8447A AMPLIFIER/ DUAL AMPLIFIER

OPERATING AND SERVICE MANUAL

MANUAL CHANGES

Model Number: 8447A
 Date Printed: APRIL 1976
 Part Number: 08447-90003

Figure 3-1. Front and Rear Panel Controls and Connectors

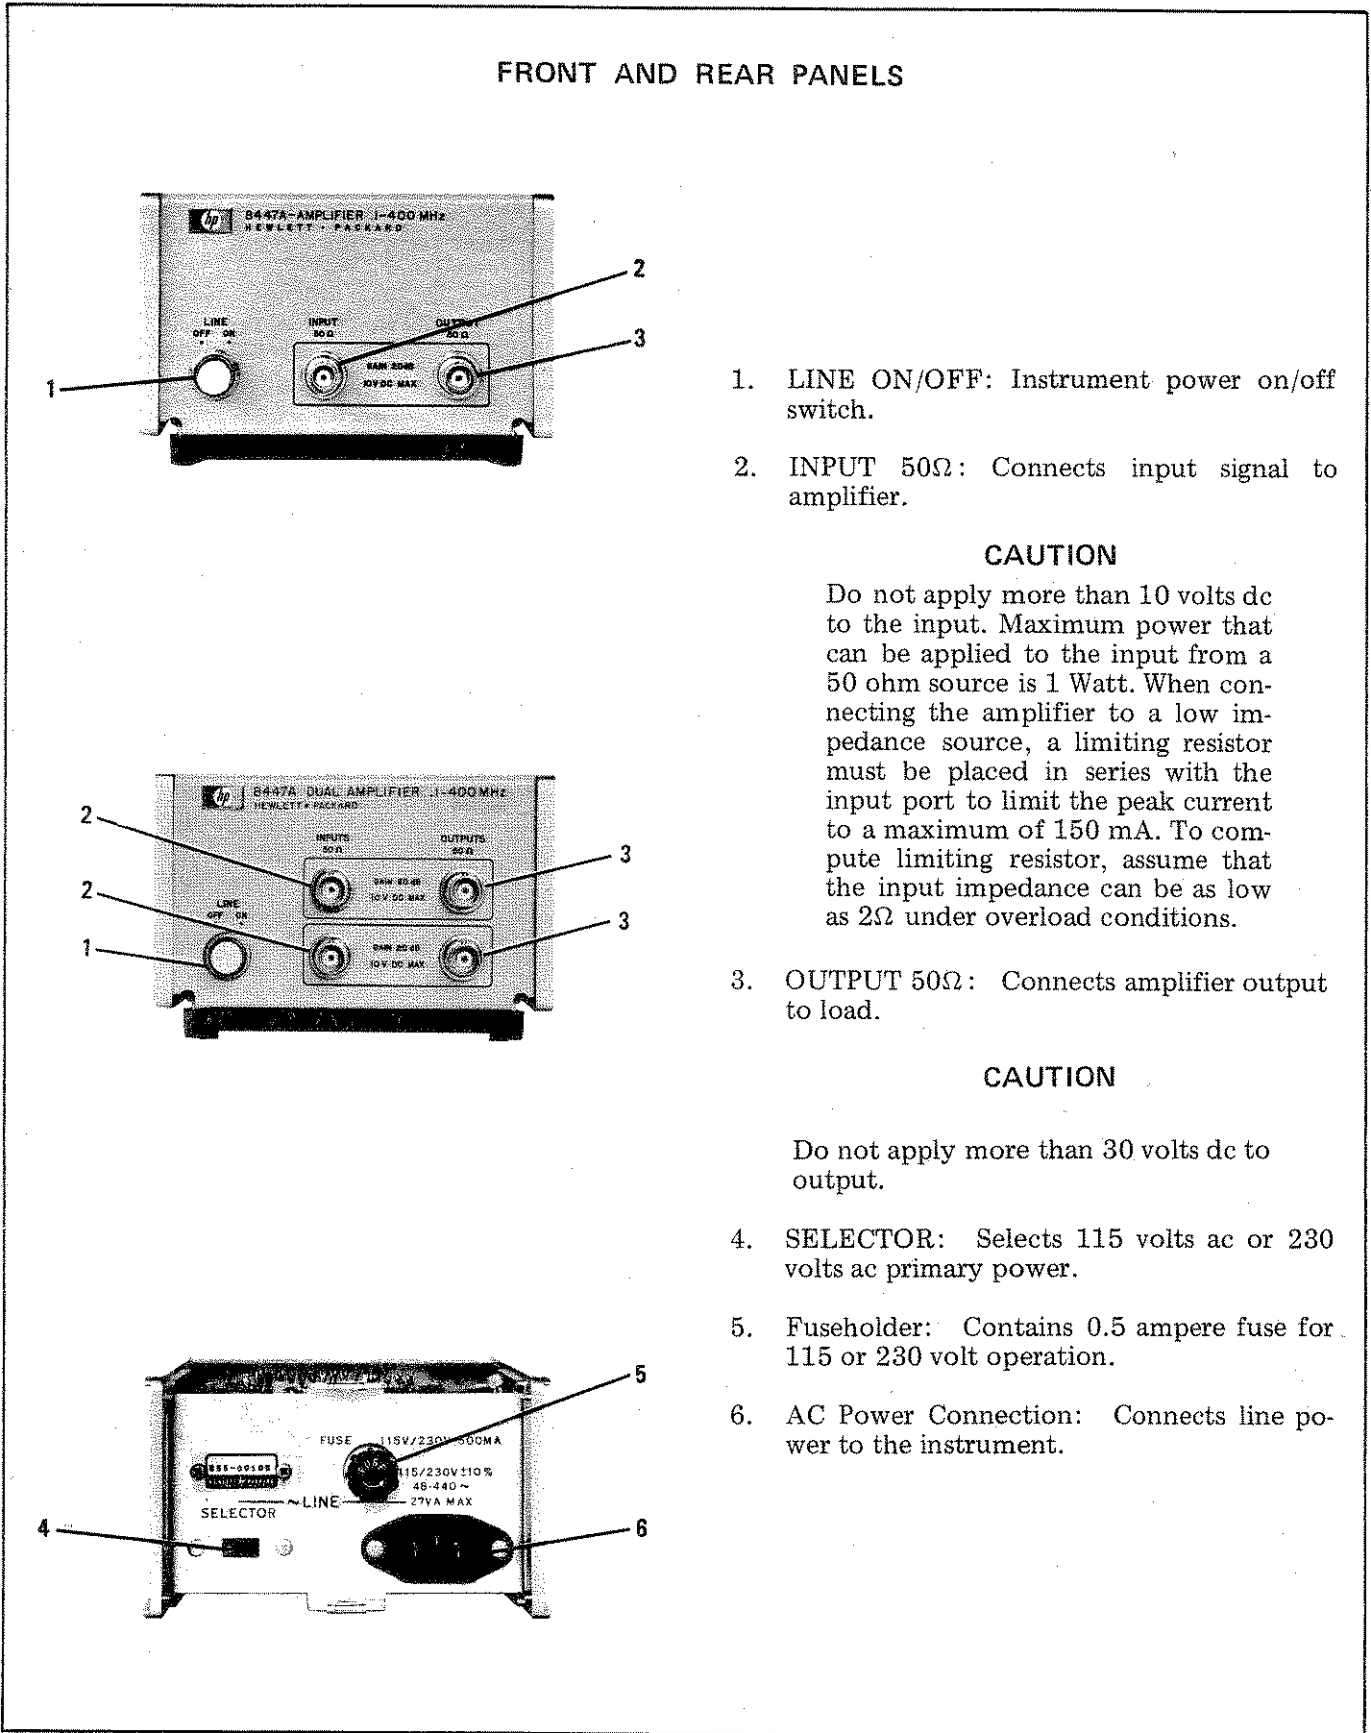
Add the following caution before the first sentence in step c:

The input to the HP 8447A amplifier is very susceptible to damage from electrostatic discharge. Before connecting any coaxial cable to the input jack of the amplifier, make certain that static electricity buildup in the cable is completely discharged.
